**Continuing Obligation Review** Form 4400-232 (R 07/22) Page 1 of 7 BRRTS ID No. 02-13-561937

Reviewer:	Caroline	e Rice		Region: SCR	Review Date:	09/25/2023
Site Name	e: Jims Mo	onroe St	Cleaners Former	_		
			s http://intranet.dnr.state.wi.us	- slint/aw/rr/quidanco/PB	E242 ndf Stone with	an * donoto DNP
follow up	: ** denot	e RP/pro	perty owner follow up. If audit	ing a VPLE site, use th	e applicable LUST or	ERP BRRTS
number.	Úse the N	OTES aı	perty owner follow up. If audit ea in each section to add infor	mation not otherwise a	addressed.	
File Revie	ew:

Title: Sidewalk in front of building. Looking northeast 9/25/2023

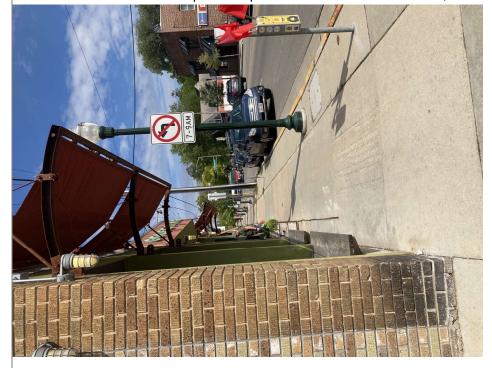
6.** Are additional actions by the RP property owner warranted at the site?	
with continuing obligation. If a significant land use change has occurred, and determine if the site meets the NR 726 reopening criteria.)	l/or further remedial action is needed,
No	lidentify who is responsible:
<ul> <li>Yes – Summarize the actions needed to return the site to compliance and One manometer is missing. One manometer is broken. Manometer</li> </ul>	
evaluated	tiers need to be invedude the system must be

7. * Does the site require follow up by DNR?			
○ No			
Yes: [	contact or enforcement to return site to compliance with continuing obligation		
	updating BRRTS for the CO PDF (adding or modifying a packet)		
	reopen site (add ACs 186, 12 and 13)		
	other: Confirm that repairs were made
